COMMUNITY DEVELOPMENT DEPARTMENT REPORT

SUBJECT: H-2025-0030
Cherry Blossom East Subdivision

LOCATION: 523 W. Cedarburg Dr. and the 0.67-acre property to the east, located in the NE 1/4 of Section 12, T.3N., R.1W. (Parcel #R1386850820 & #S1212120695)

Common Drive

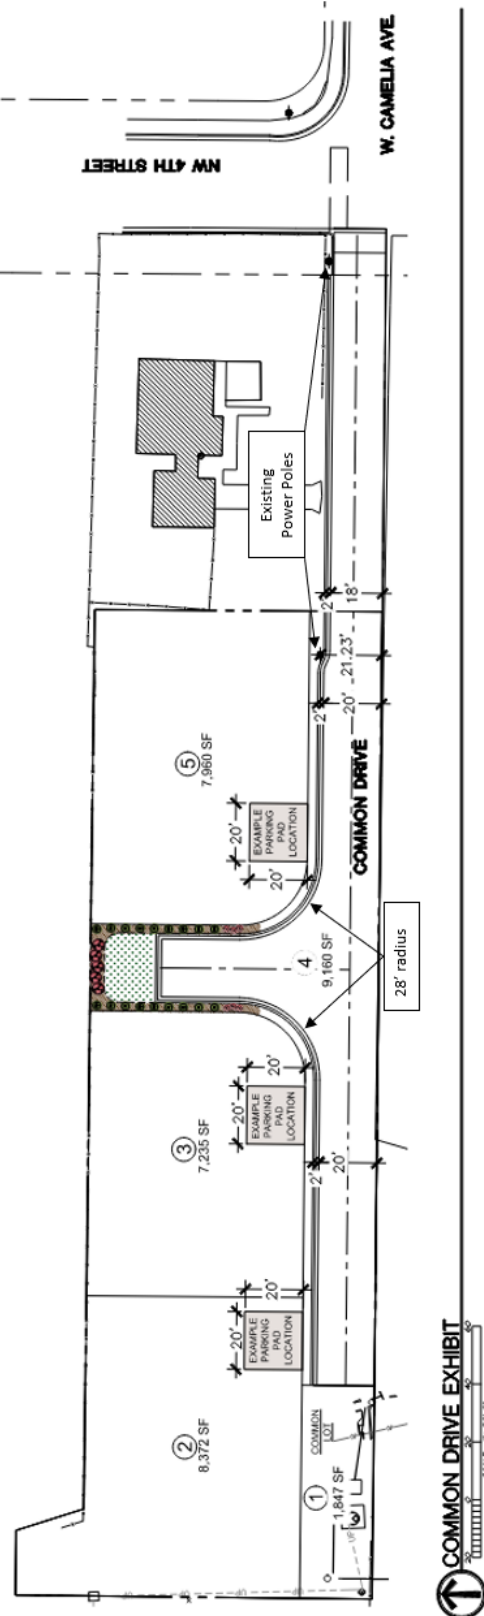
The width of the existing driveway on the Fusselman property and the proposed common driveway on the subject property is slightly constrained due to the location of a power pole and retaining wall on the Fusselman property and a power pole on the subject property, as shown on the common driveway exhibits below in Section VII.F. Because these constraints are existing conditions, the Fire Dept. and Planning Division have approved the driveways as shown on the exhibits.

~~The driveway is required to be 20 feet wide — rolled curb may be provided if needed for drainage at the back edge(s) of the driveway; the common driveway exhibit should be revised accordingly prior to the City Council hearing to reflect a 20-foot wide flat driving surface or alternative compliance should be requested to UDC 11-6C-3D.2 if the width cannot be accommodated.~~ The proposed driveway is 370 feet long, which exceeds the desired length standard of 150 feet or less. Driveway lengths exceeding this standard may be allowed if approved by the Meridian City Fire Department – Fire Dept. has granted approval of the proposed driveway length. **The driveway is required to be paved with a surface capable of supporting fire vehicles and equipment – plat note #78 should be amended to require maintenance of such for that purpose; the ingress/egress easement is also required to be perpetual and should be included in plat note #78 as such. The developer has stated maintenance of the common driveway will be the responsibility of the three (3) lots that take access from the driveway.**

- Meridian Fire Department requires 20' wide driving surface with approved turnaround
- 5' buffer requirement removed by Planning Staff
- Proposed common driveway has 20' wide asphalt driving surface with 2' mountable curb west of the onsite power pole
- Approval granted from Planning and MFD to reduce overall width to 20' (18' asphalt driving surface with 2' mountable curb) east of onsite power pole to maintain site drainage control, address power pole conflict, and keep improvements within the 20' wide access easement across the property to the east
